BRE Client Report

Review of daylight, sunlight, overshadowing and privacy, Hornsey Town Hall, London

Prepared for: Dr Paul Toyne
Date: 9 November 2017

Report Number: P110053-1000 Issue: 2

Figure 4. Plan by Make Architects of first floor of mews building, annotated to show views from side windows.

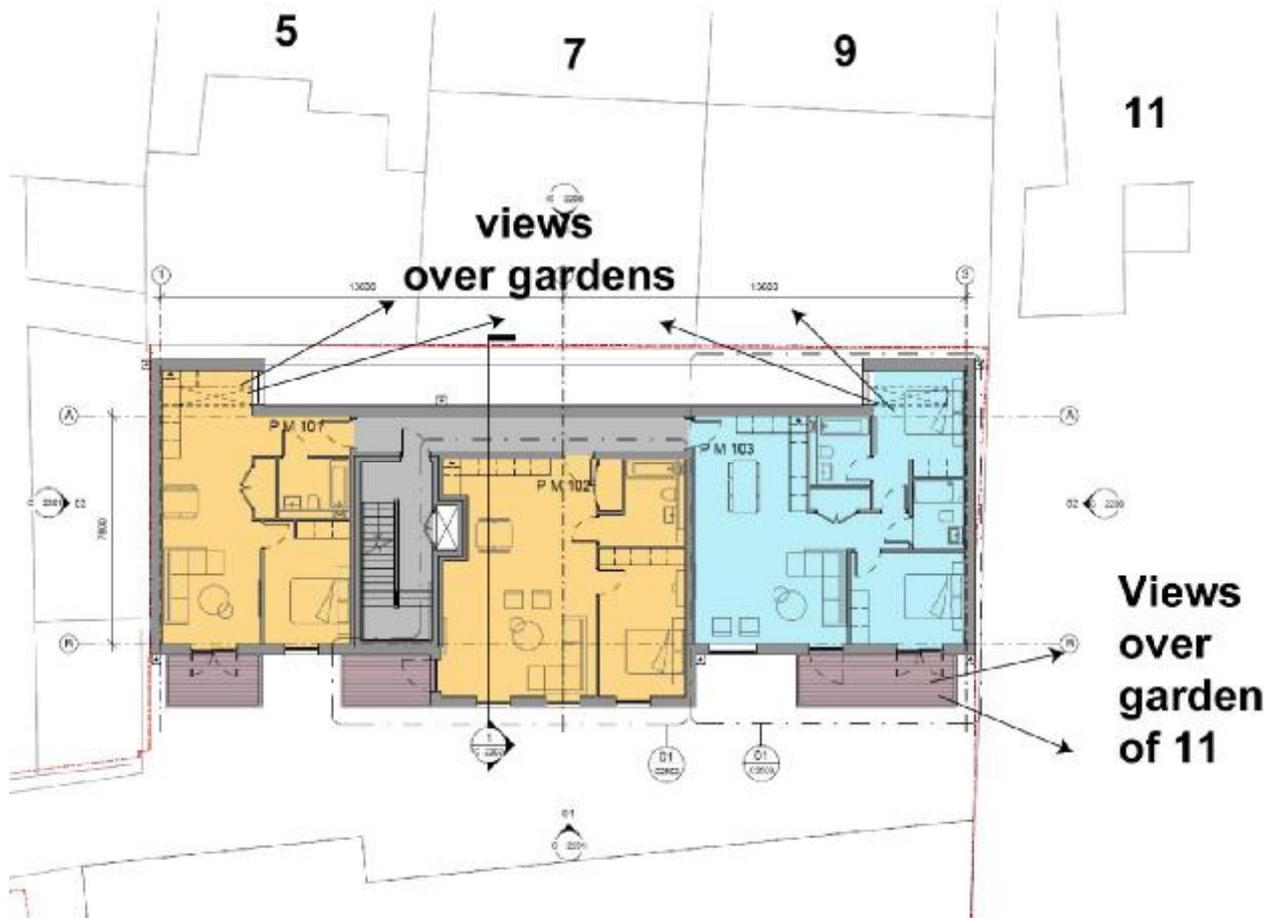
level. Strictly speaking this is true, but there are also normal height windows in small extensions at the sides of the building, see Figure 4 below. On the first floor they light a kitchen and bedroom, on the second floor a bedroom and bathroom. The bedroom windows at least would be expected to be of clear glass.

- 3.2.7 From these windows there would be some overlooking of rooms at the rear of numbers 5-9, which would only be 10-15 metres away. However the main privacy issue would be to the gardens, as people in the new mews flats would be able to look down on the gardens directly below them. This would constitute a substantial increase in overlooking and loss of privacy. Currently because of the locations of the extensions it is difficult to look from numbers 5 and 9 into the garden of 7, and vice versa. However people in the new development would be able to see all three gardens quite clearly.
- 3.2.8 There would also be unwanted overlooking of the southern part of the much longer garden to number 11 from the easternmost balcony on the other side of the new development, see Figure 4. People would be able to sit on this balcony and look down on the garden.
